LOCA Aspects of the Combustion Engineering Advanced Light Water Reactor — System 80 +

TIS-8328

Question 720.6

Loss of Offsite Power Event Tree

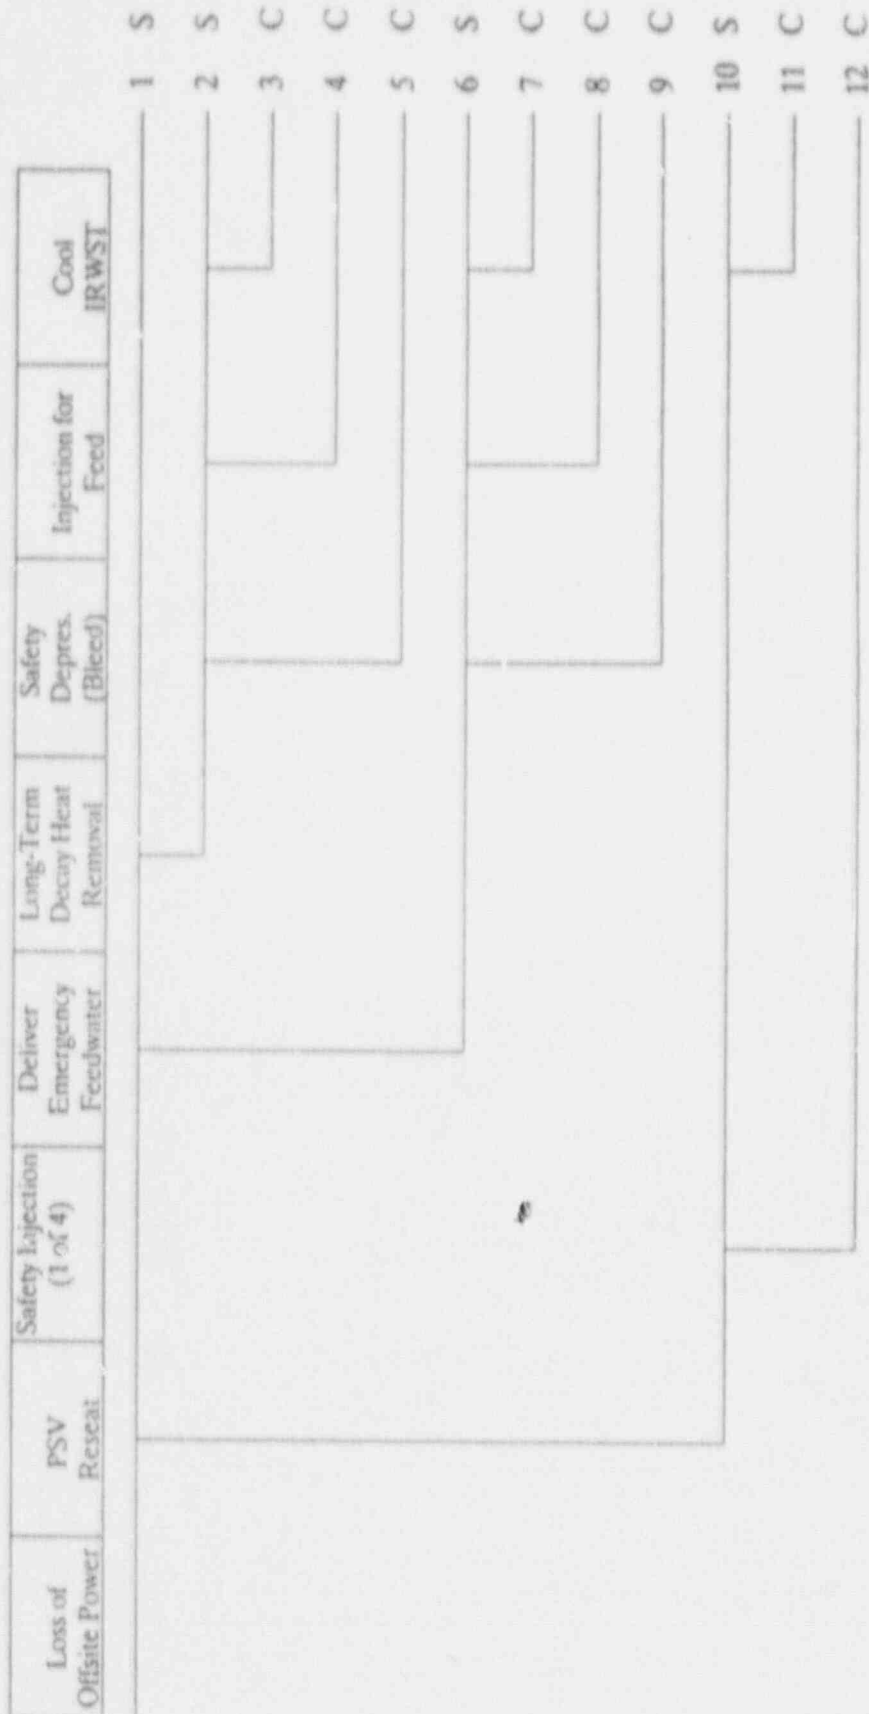
On page B-67 of the CESSAR, Appendix B, it is stated that "failure of a PSV to reseal after the primary side pressure decreases will result in a small Loss-of-Coolant Accident (LOCA) with offsite power unavailable. This is considered to be a small LOCA initiator for quantification of small LOCA frequencies." Essentially identical statements are also made on page B-144 for Tornado strike sequence analysis. Were these sequences actually transferred to the small-LOCA event tree? If so, what are their frequencies?

The statements regarding PSV LOCAs following a LOOP or tornado strike initiator are incorrect. These "consequential" small LOCAs were treated within the appropriate event trees as shown in figures B3.1.8-1 and B4.2.3-1 (presented here for convenience). The statements on pages B-67 and B-144 were inadvertently left in from a previous iteration of the PRA. C-E is in the process of updating the System 80+ PRA and these statements will be deleted.

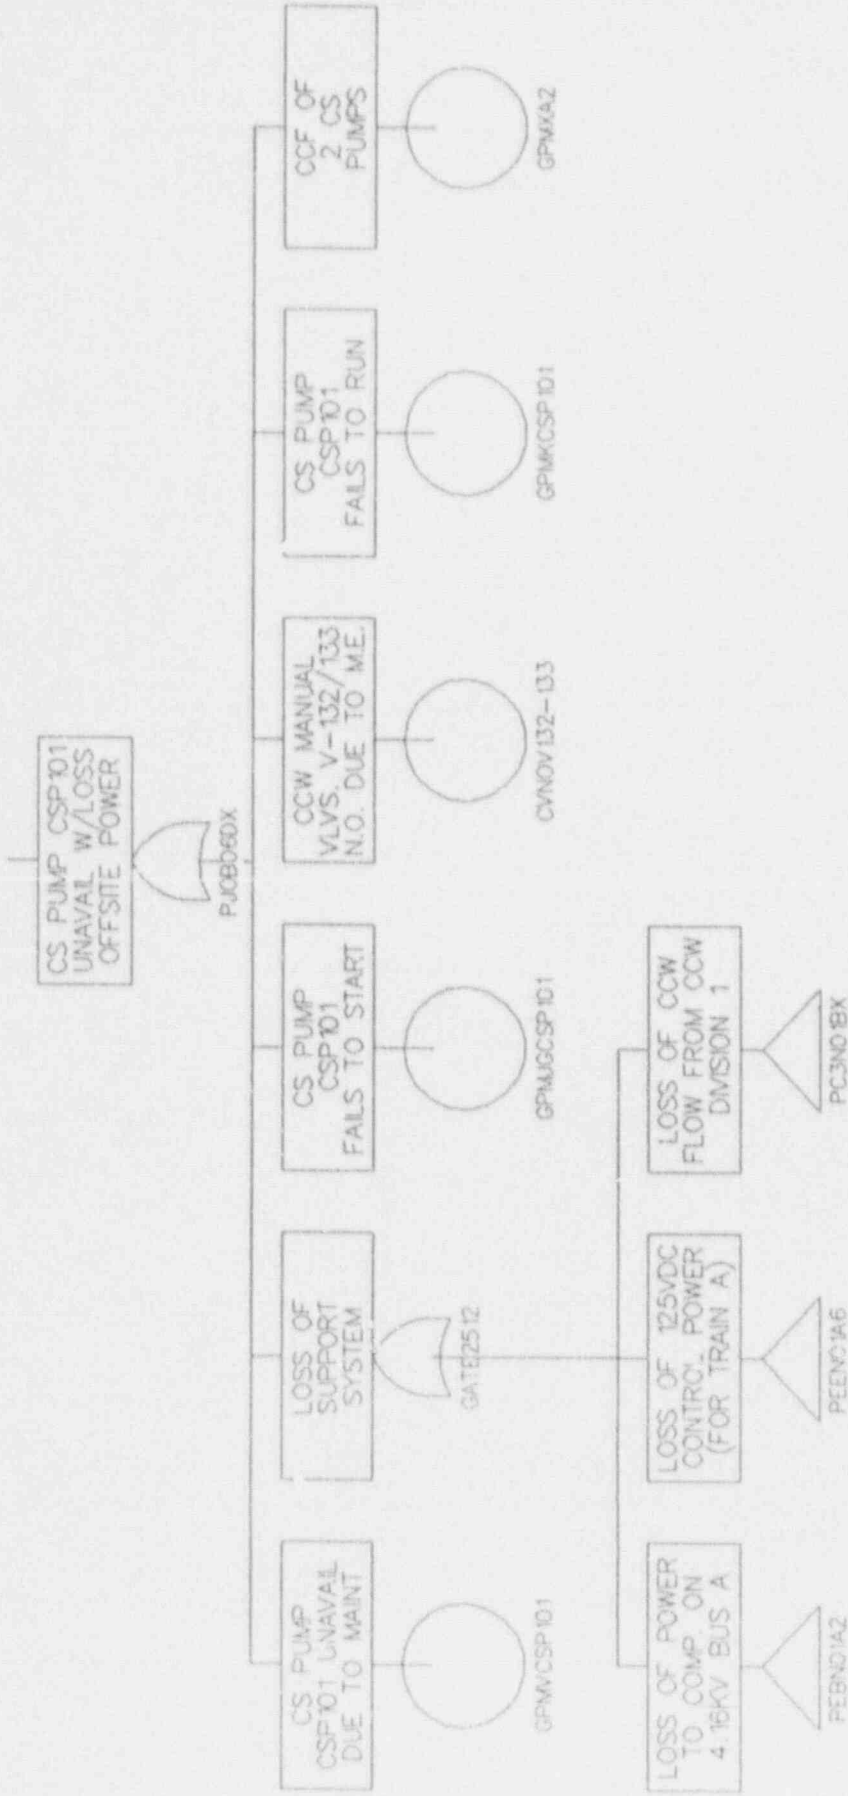
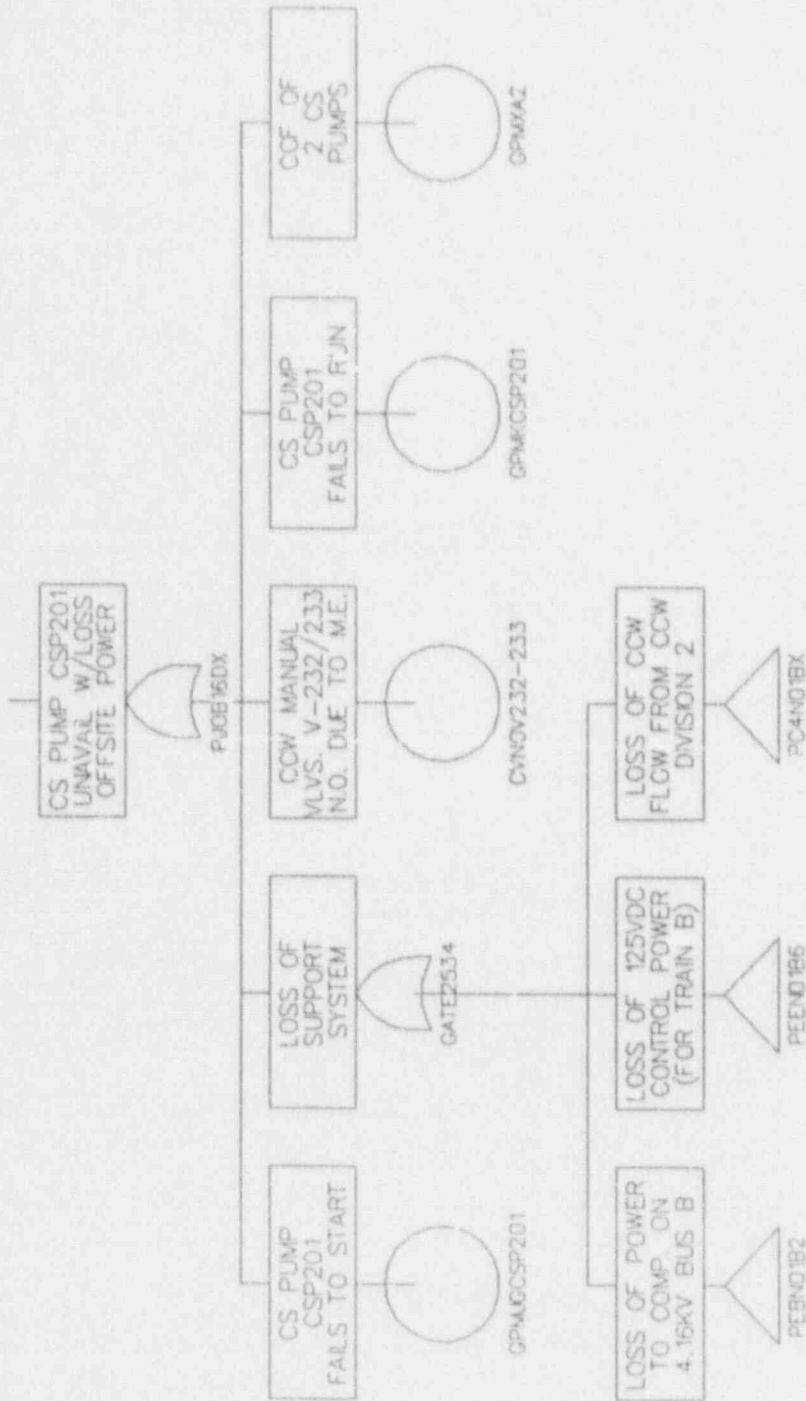
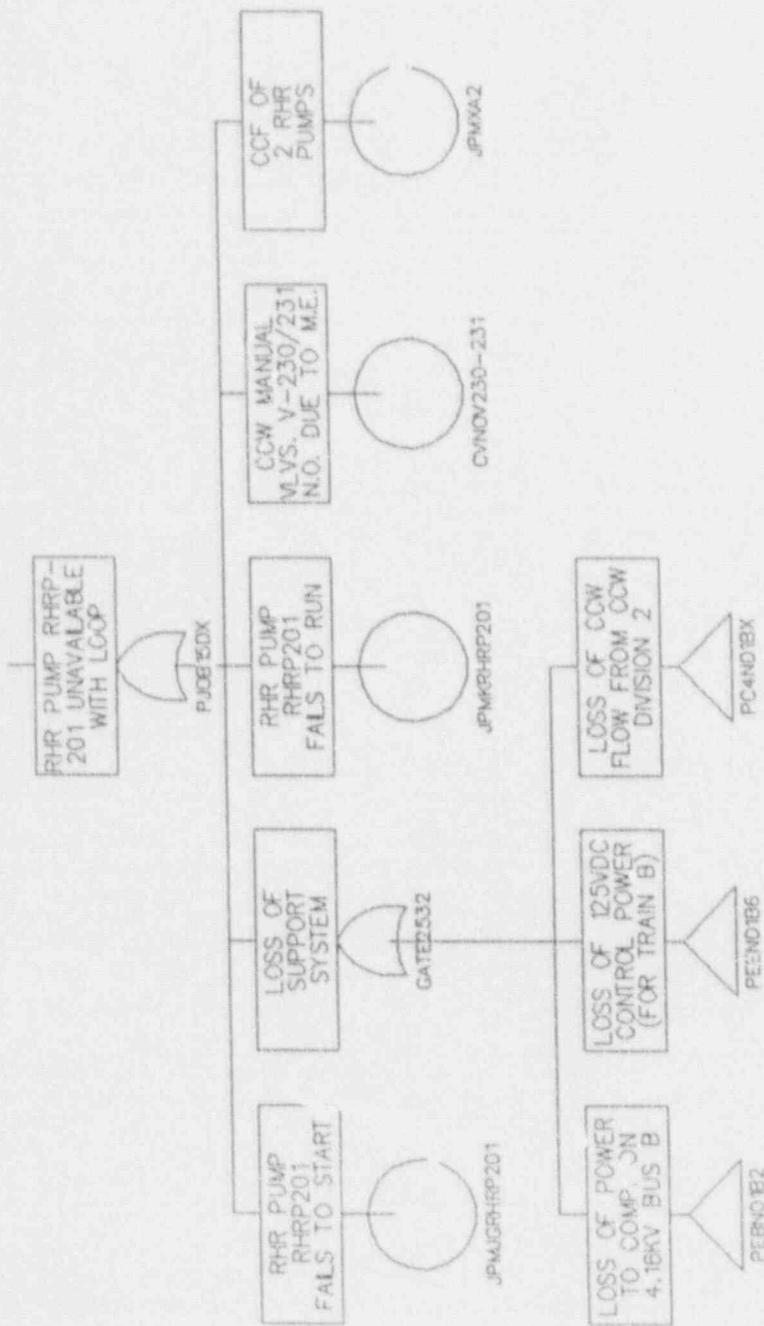
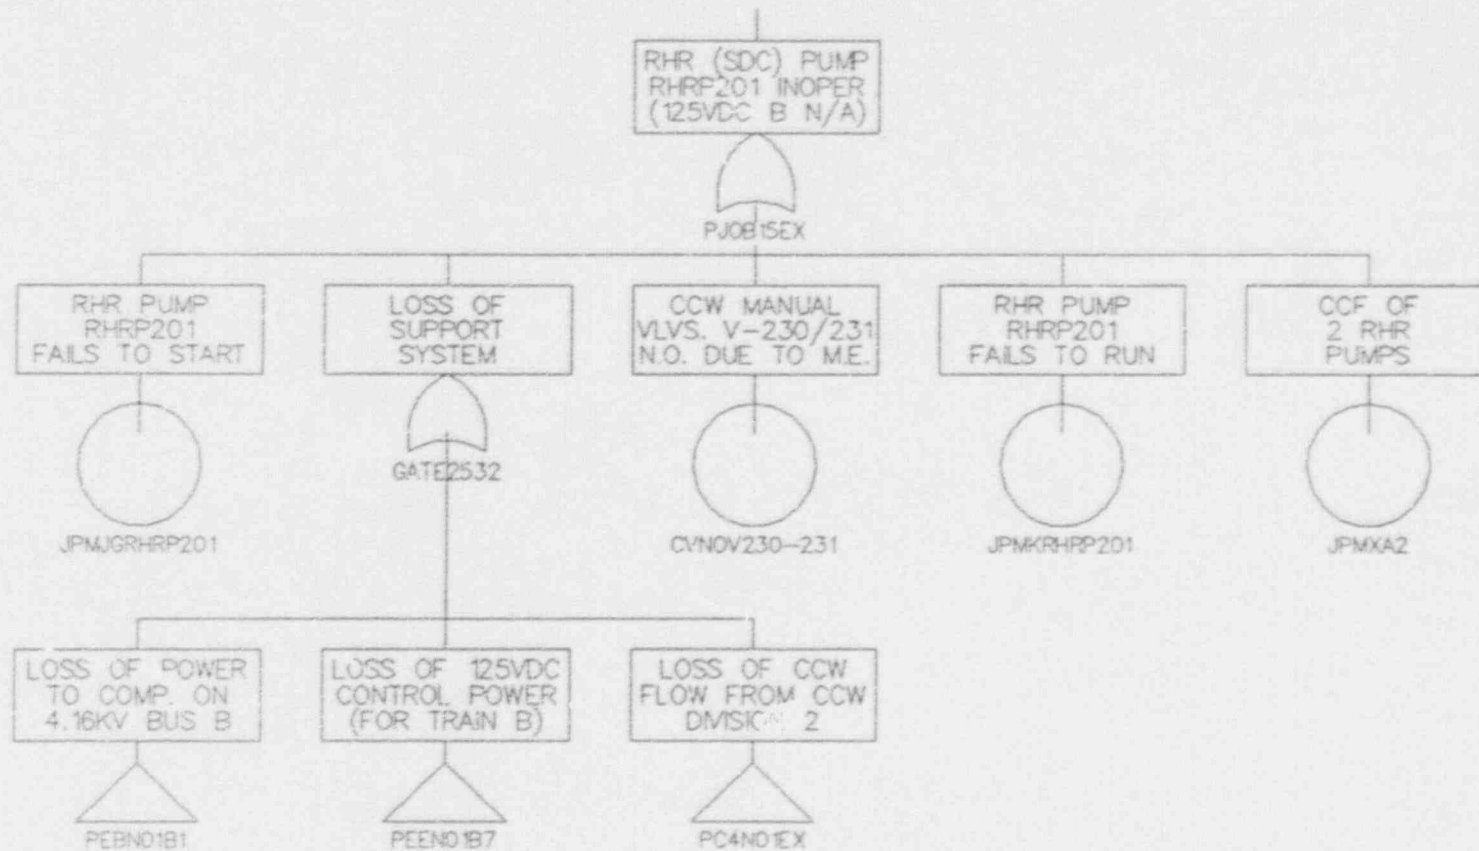
Loss of one component cooling water division, loss of 125 Vdc vital bus, or loss of a 4.16 KV vital bus all have some impact on the availability of the containment spray system. No clear treatment of the relevant impacts, however, can be found in the fault trees (Figure 6.3.13-2) developed for failure of the containment spray system. Please explain why they are not modeled.

The fault tree developed for unavailability of RHR pump-101 given loss of a component cooling water division is presented as PGIB14CX in Figure 6.4.2-7 (on page 6-845).

Also, it is to be noted that, as described in subsection 6.3.1.1.3.11 and depicted in Figure 6.3.1-2, the 125 VDC class 1E power system consists of six independent and physically separate load groups. Each load group includes a battery, a battery charger and DC distribution center. The battery chargers of load group channels A, C and division I are powered from division I of the 480 VAC power system. Similarly, the battery chargers of load group channels B, D and division II are powered from division II of the 480 VAC power system. Furthermore, the ESF equipment which is loaded on the 4.16 KV or 480 V bus is provided with redundant trip coils. Control power for the trip coil circuitries is assumed to be obtained from the 125 VDC buses A and I for division I equipment and from 125 VDC buses B and II for division II equipment. The CS and RHR pumps in train B are powered from division II power system, thus the control power for these pumps can be from 125 VDC bus B or II. Therefore, in the event of a failure of 125 VDC bus B, these pumps do not necessarily become unavailable. For the CS or RHR pump to completely fail, failure of both the 125 VDC buses B and II must occur. The fault trees, PJOB16EX and PJOB15EX, developed for unavailability of CS pump and RHR pump, given loss of a 125 VDC bus B, correctly model such logic.
